46 FACADE BOTTOM (Northern elevation)
SECTION DETAIL

B	18.06.08	DETAIL UPDATE
ISSUE	DATE	REVISION
Use figured dimensions in preference to scale. All dimensions to be verified and checked on site.		
Project		
REFURBISHMENT SHIRE CHRISTIAN CENTRE		
Fabricator		
 Architectural Fabrications & Installations		
PO BOX 52 SEAFORTH NSW 2092 FAX: 9949 7122 PH: 9948 7861 email: made@alpha.net.au email: jon@made.com.au		
Copyright © 2002 [Made Contracting] All rights reserved		
Drawn	MASATO F.	
Builder		
Architect		
Level		
Drawing Title		
SECTION DETAIL		
Scale:	1:4	Checked:
Job Number:		Date: 22.05.08
Drawing Status:		A3
FOR APPROVAL		
Drawing No.	SCC28	Revision B

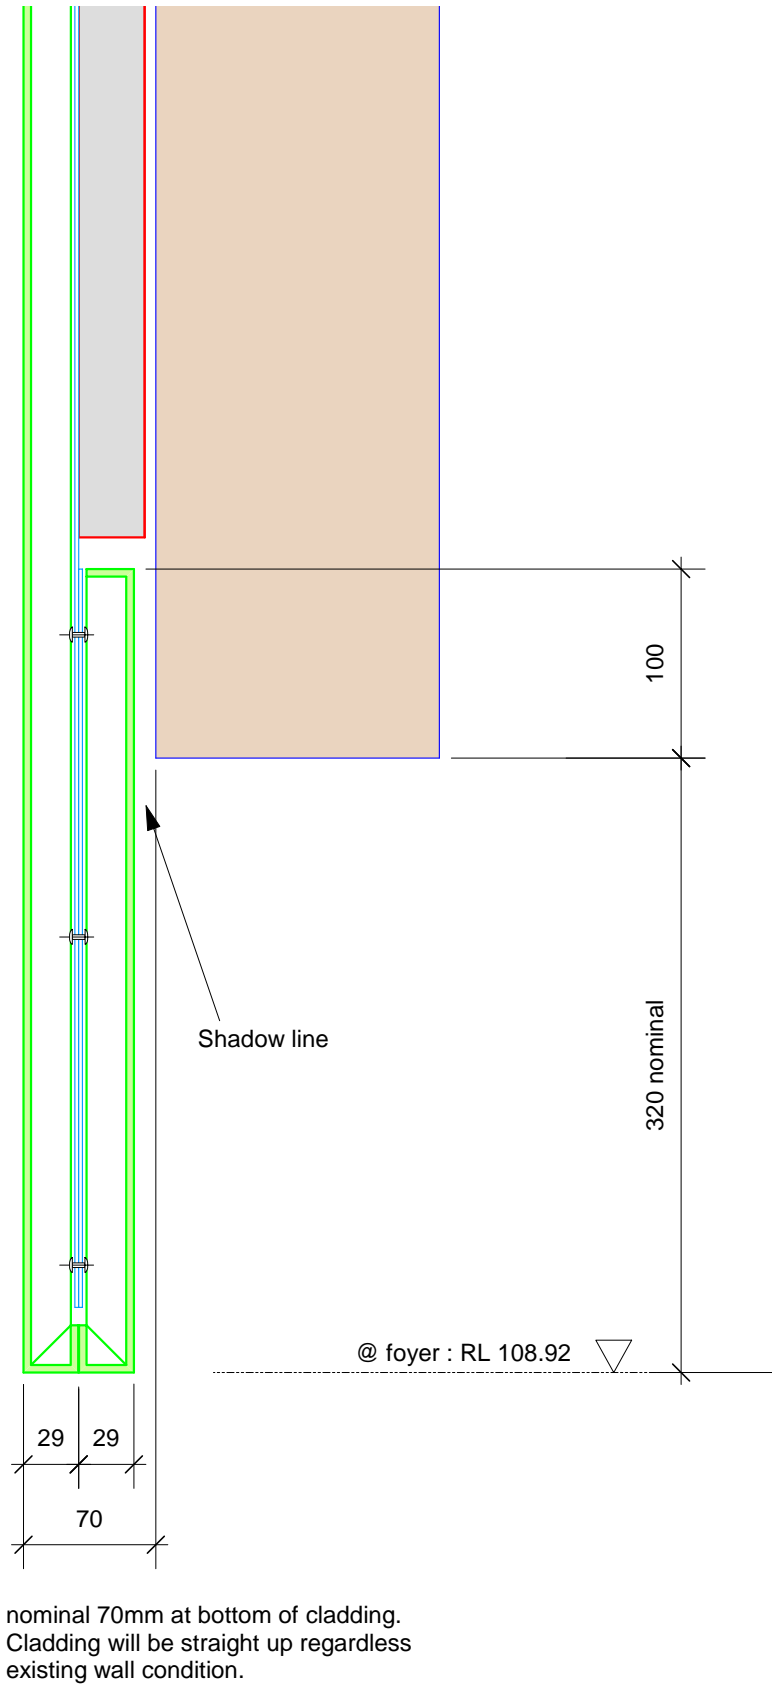
NOTE
Need insulation to avoid direct contact
between aluminium & Gal MS
